Memorandum

TO: Karl Benedict, NHDES
FROM: Chris Fournier, PE, HEB Engineers, Inc.
Andrew O'Sullivan, New Hampshire Department of Transportation
SUBJECT: Response to Request for More Information
NHDES File Number: 2020-01554
Columbia-Colebrook, 42313 – NH Route 3 over Simms Stream
Wetlands Permit Application

The purpose of this memorandum is to provide responses to the five (5) NHDES comments in narrative and plan/figure formats (see attachments). The *request language* has been included and the comments have been numbered according to the Request for More Information (RFMI) dated August 7, 2020 with responses for each below.

STATE OF NEW HAMPSHIRE	
DEPARTMENT OF TRANSPORTATION • BUREAU OF HIGHWAY DESIGN	
SIMS STREAM PROFILE & CROSS SECTIONS

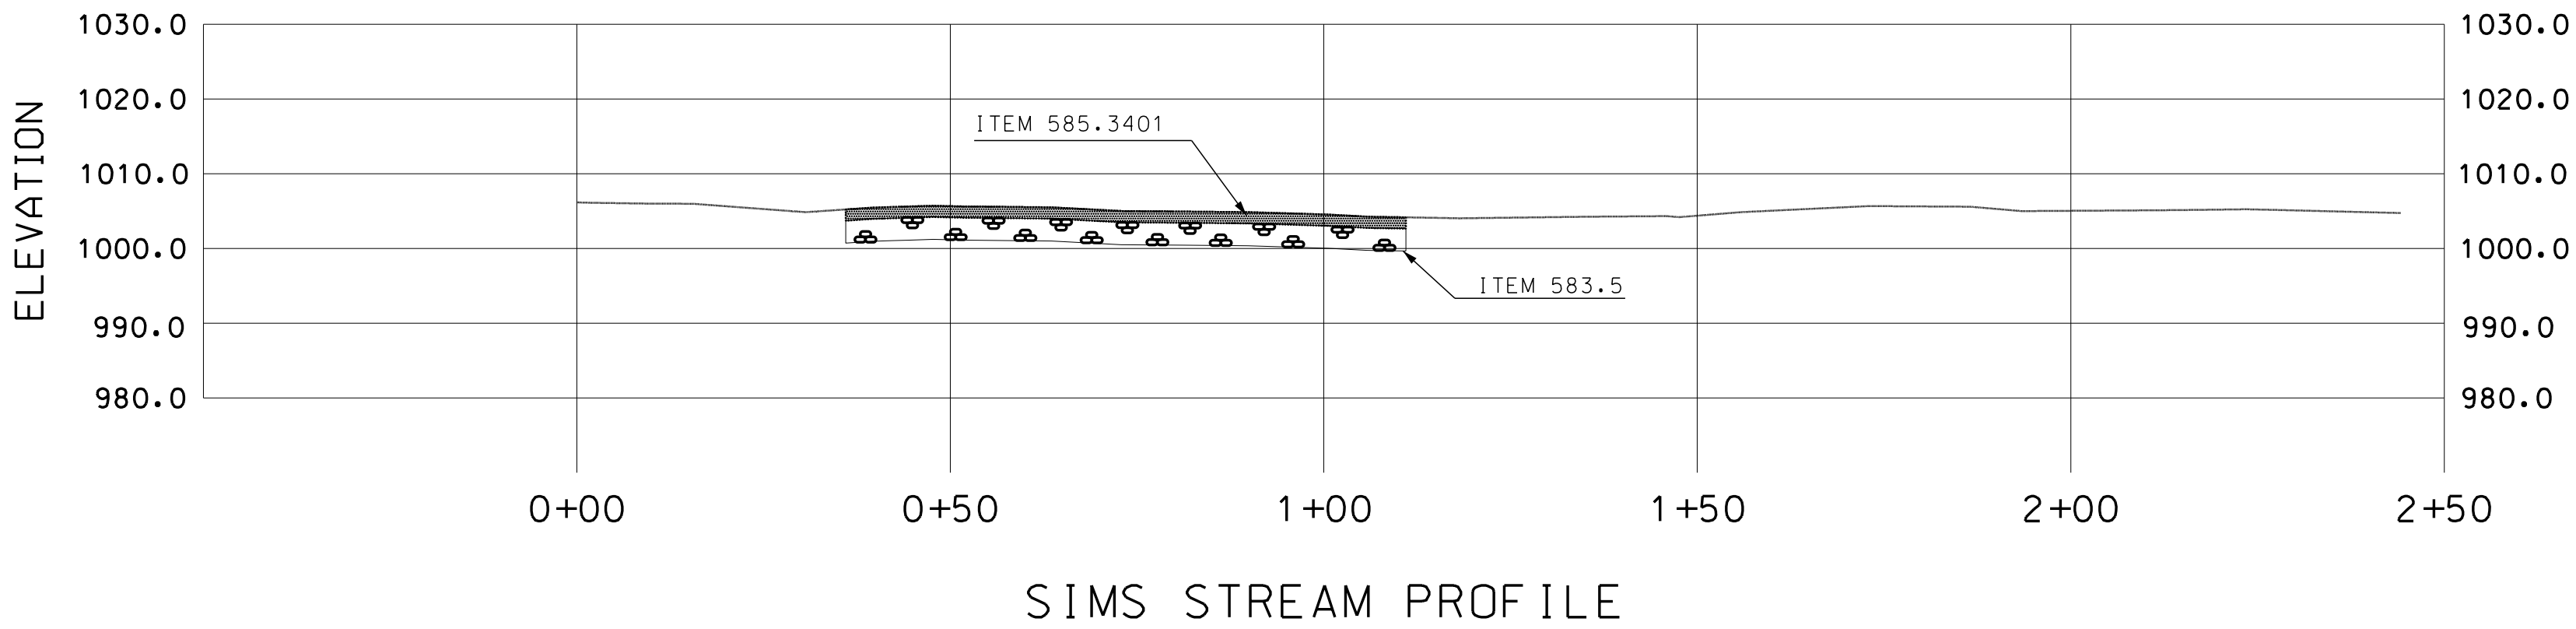
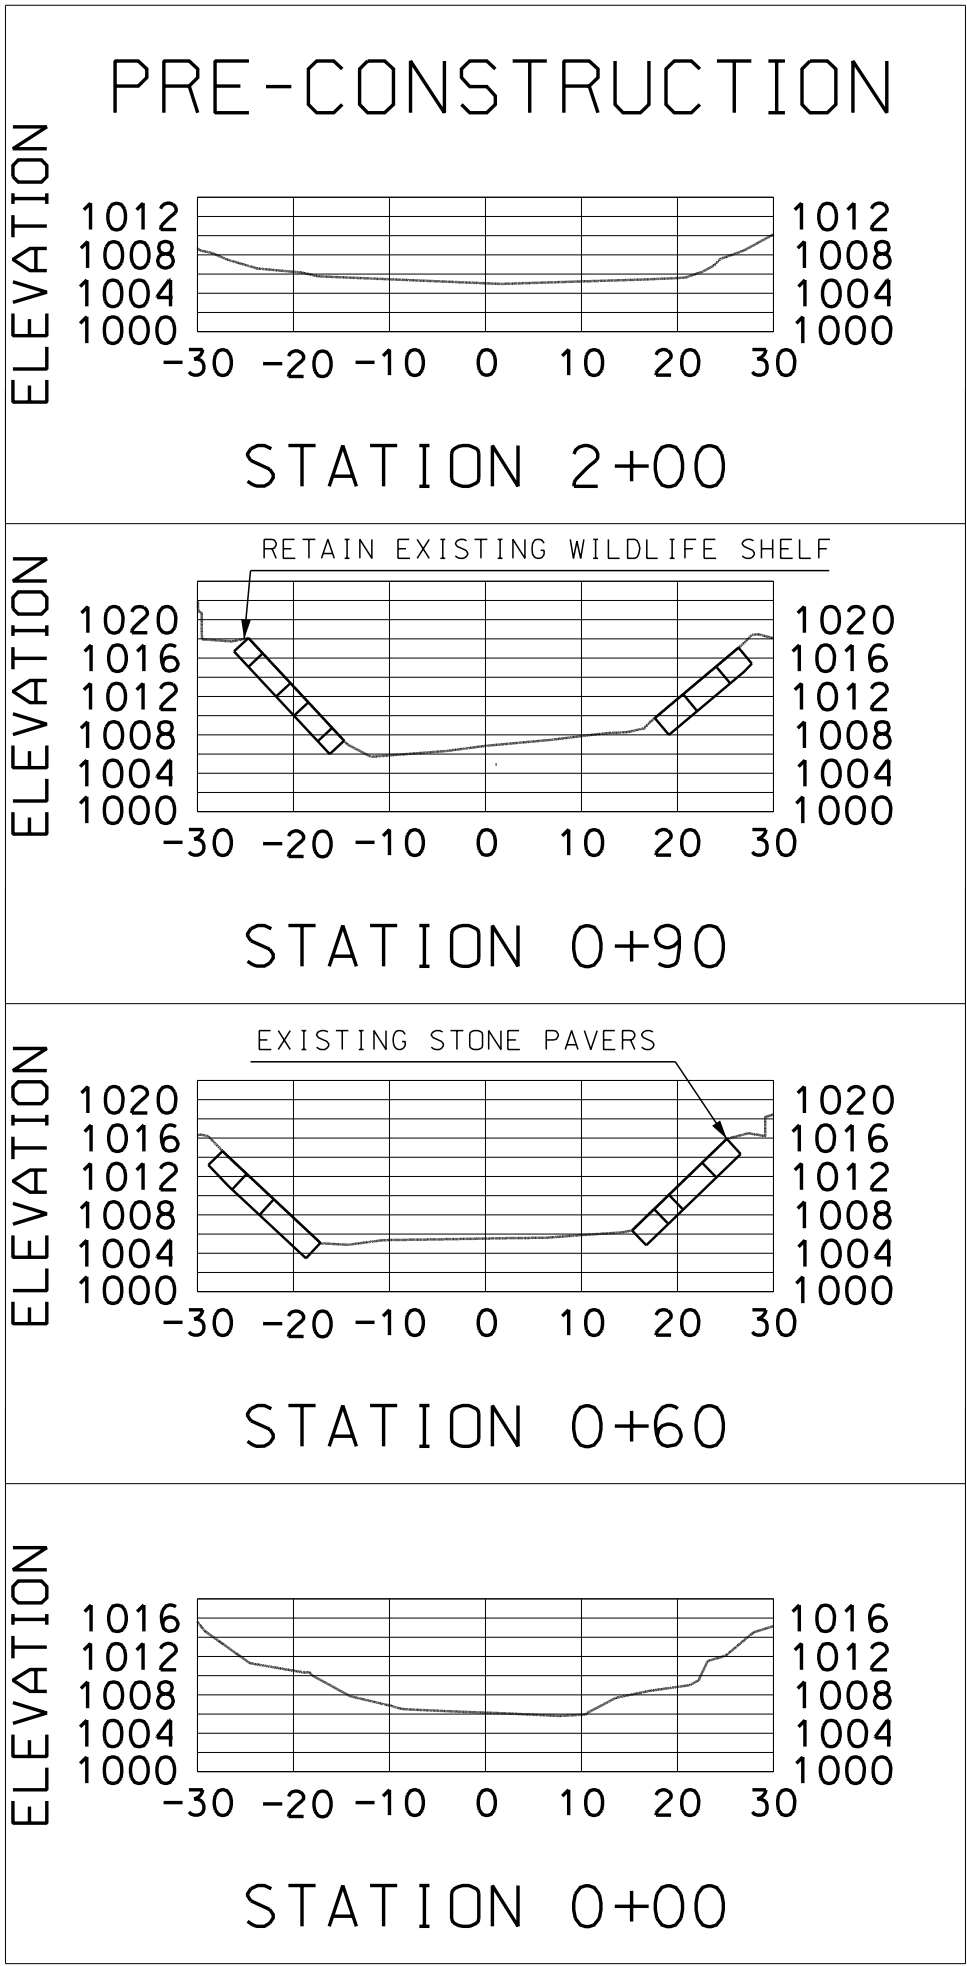
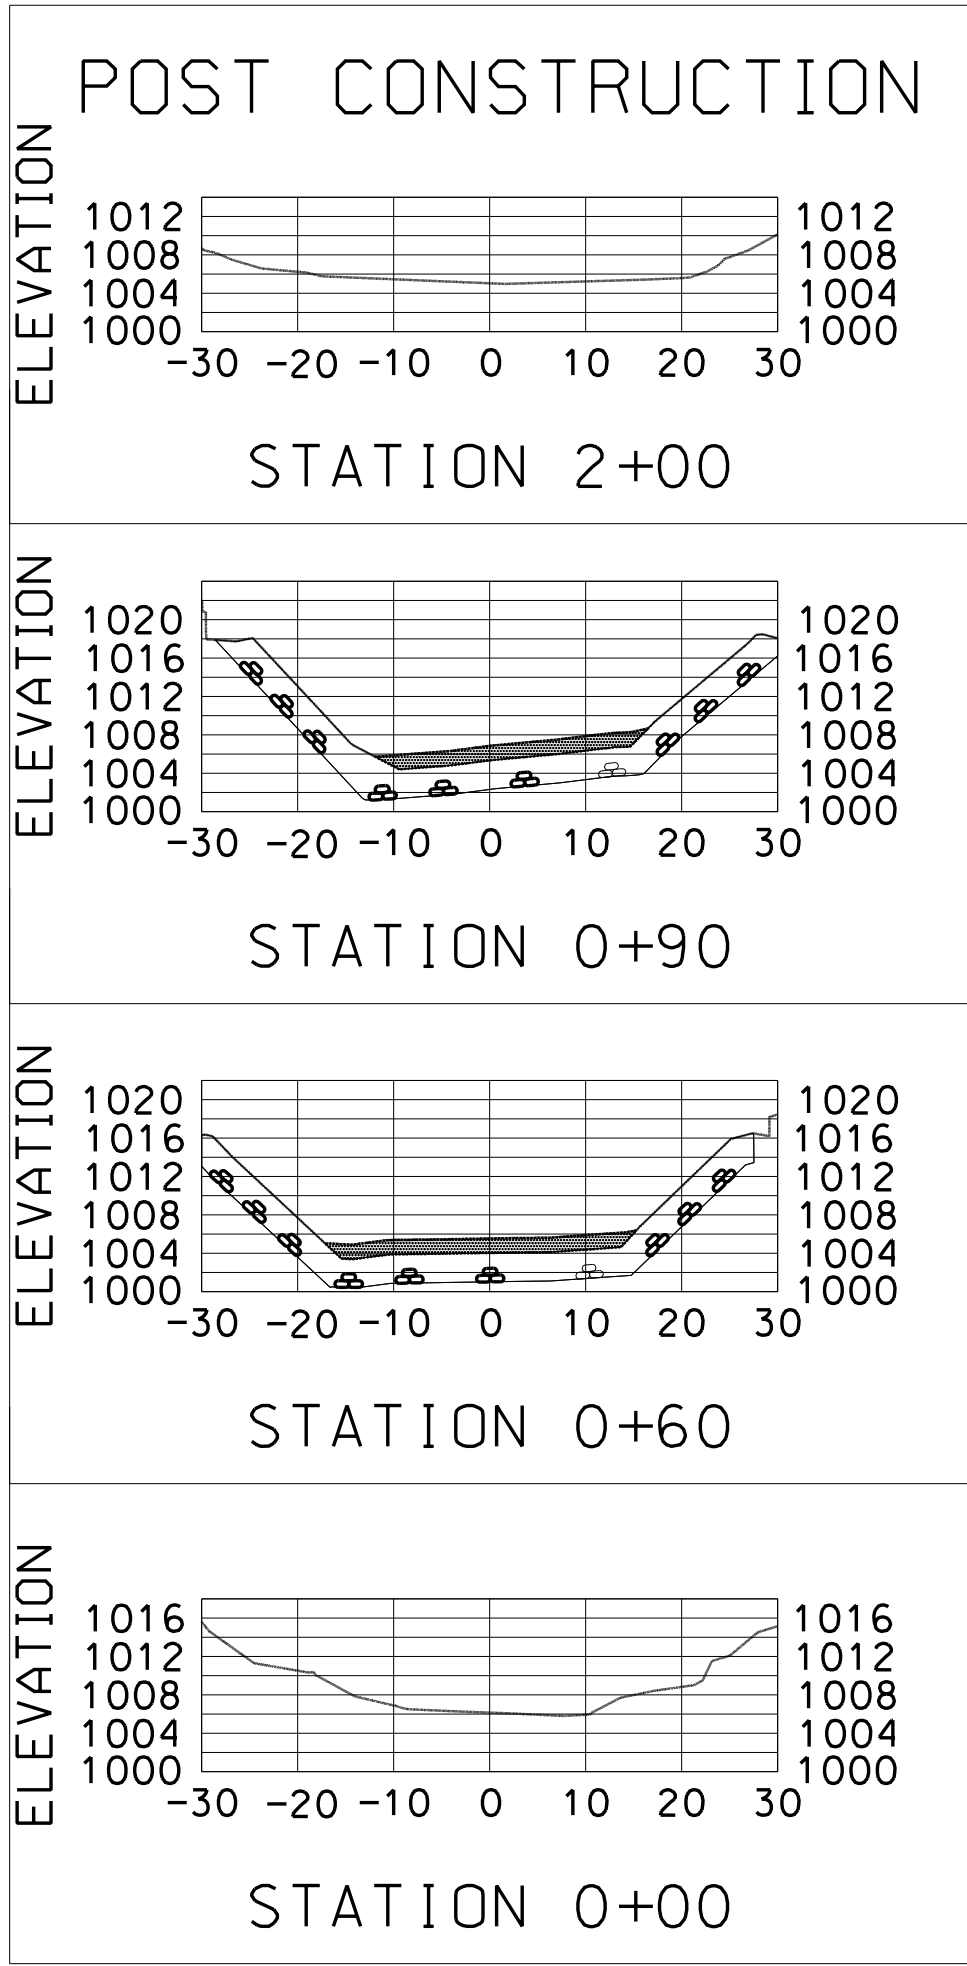
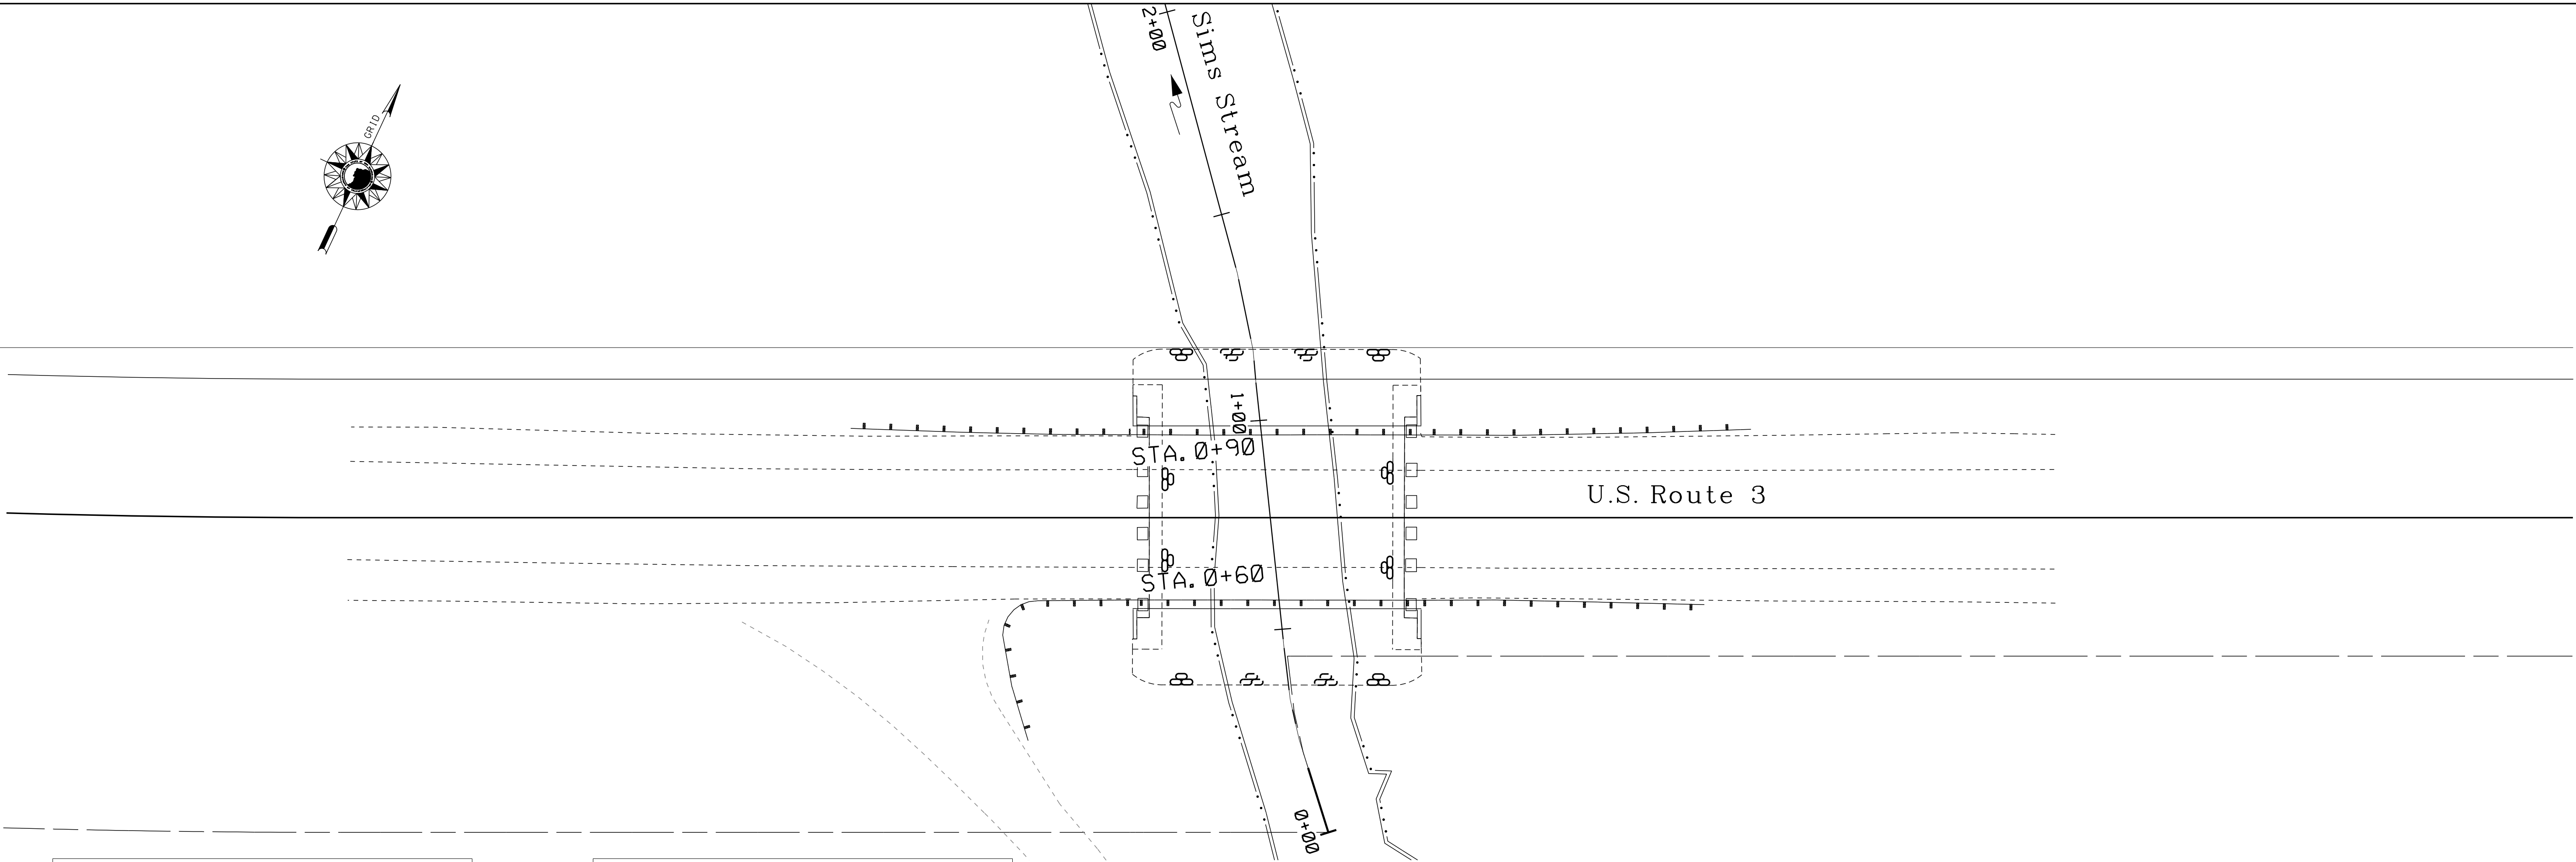
3. NHDES Comment: *The application narrative which was presented at the December 18, 2019 Natural Resource Agency Coordination Meeting indicates "To key the channel protection and keep it in place, the banks and entire channel bed under the bridge will be disturbed; riprap will be removed, existing channel materials will be excavated and stockpiled, and then reinstalled at essentially the same elevation and slope as the existing riverbed, on or top of the stabilized channel. Prior to removing and stockpile the existing riverbed material, the existing configuration of materials will be noted, and replacement will mimic that to the extent practicable", and asserts that "Because the impacted areas will be restored to preconstruction conditions and geometries using native and new materials; and per coordination and discussion at the NHDOT Monthly Natural Resource Agency Coordination Meeting (December 18, 2019) mitigation will not be required and has not been proposed". In accordance with Env-Wt 514.02 Approval Criteria for All Bank/Shoreline Stabilization Projects. (b) Bank/shoreline stabilization shall: (3) Not adversely affect the stream course such that water flow will be transported by the stream channel in a manner that the stream maintains its dimensions, general pattern, and slope with no unnatural raising or lowering of the channel bed elevation along the stream bed profile. Please provide a cross-section/longitudinal plan that identifies the specific work, including existing and proposed conditions, in order for NHDES to confirm proposed work will be restored to preconstruction conditions and geometries with native material, identification of any new materials and their locations, and associated elevations within the stream bed. The information is also necessary to confirm that the hydraulic compatibility of the crossing will not be affected. Please identify how this specific methodology will be transferred per plan and narrative to the Contractor.*

4. NHDES Comment: *The stream crossing location has been identified within the Highest Ranking Habitat in NHFG Wildlife Action Plan. Discussion during Natural Resource Agency meeting requested considerations for terrestrial wildlife passage to be incorporated into the project design. The project wetland scientist had noted that the existing topography adjacent to and under the bridge provides a suitable pathway for medium- and smaller-sized wildlife to use the bridge for passage under the roadway. Please identify how this passage consideration has been incorporated into the project design through cross-section and longitudinal plans.*

Response: A cross-section/longitudinal plan that identifies the specific work including existing and proposed conditions to verify that the proposed work will be restored to preconstruction conditions and geometries has been included in the Revised Plans (see Attachment A). The plan identifies the location and depth of new materials proposed to be installed below existing grade. The hydraulic compatibility of the crossing will not be affected given the restoration of channel geometry to pre-construction conditions. These pre-construction and post-construction conditions have been detailed in both profile view as well as associated cross sections. All views of the proposed and existing

conditions are given to scale and with specific elevations and should be readily understood by the Contractor.

Response: As indicated at the Natural Resource Agency meeting, the existing topography adjacent to and under the bridge provides a suitable pathway for medium- and smaller-sized wildlife passage under existing, preconstruction conditions. The proposed project would maintain the existing topography to allow for the maintenance of the preconstruction wildlife crossing following the completion of work. No adverse changes to the ability for wildlife to pass under the bridge and avoid the roadway are anticipated. See existing and proposed cross-sections in Attachment A.
